Heritage Trust of Nova Scotia
1588 Barrington Street
PO Box 36111, RPO Spring Garden, Halifax, B3J 3S9

Chair and Members of the
Heritage Advisory Committee
Halifax Regional Municipality

The Heritage Trust understands that an application to substantially alter five registered heritage properties in the block bounded by George, Granville, Duke and Hollis Streets in Halifax will come before the committee next week.

Examples of Historic Architectural Features and Craftsmanship that would be destroyed if the application of Case ~~1976~~ *HCO395* were approved:

Flinn Building—West Window

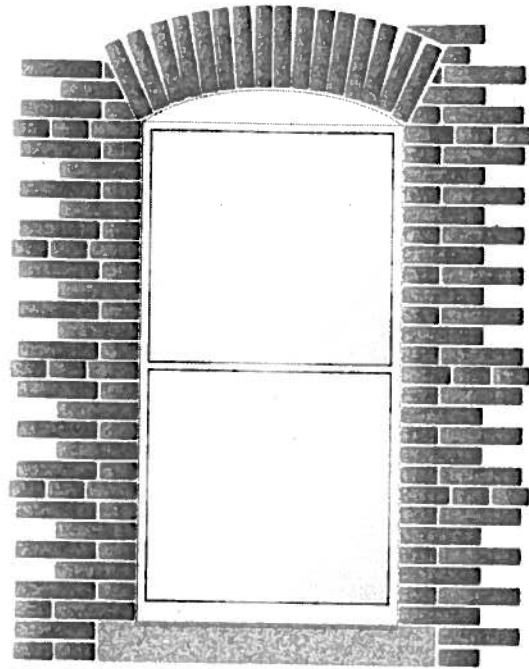
Top Right: One of six windows on the west elevation of the Flinn Building, with voussoirs forming a segmental arch at the top and with a granite sill below.

Champlain Building—West Window

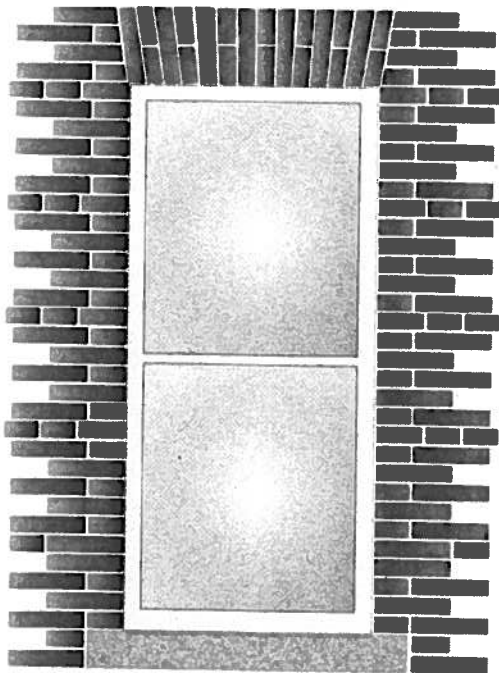
Bottom Left: One of six windows on the west elevation of the Champlain Building, with voussoirs above and a granite sill below.

Flinn Building—Dormer Window

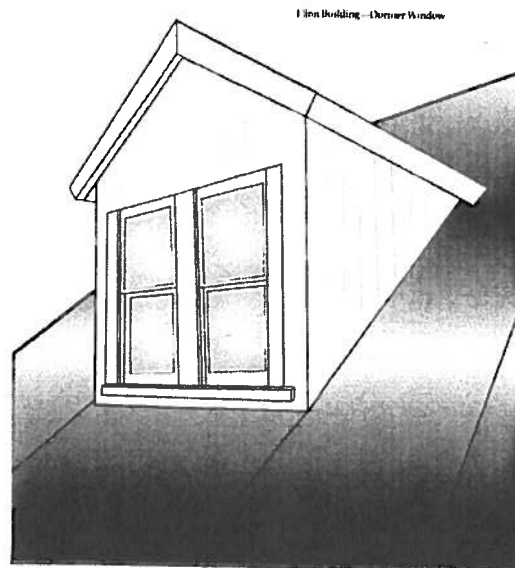
Bottom Right: Gabled dormer on the west slope of the truncated pitched roof of the Flinn Building.
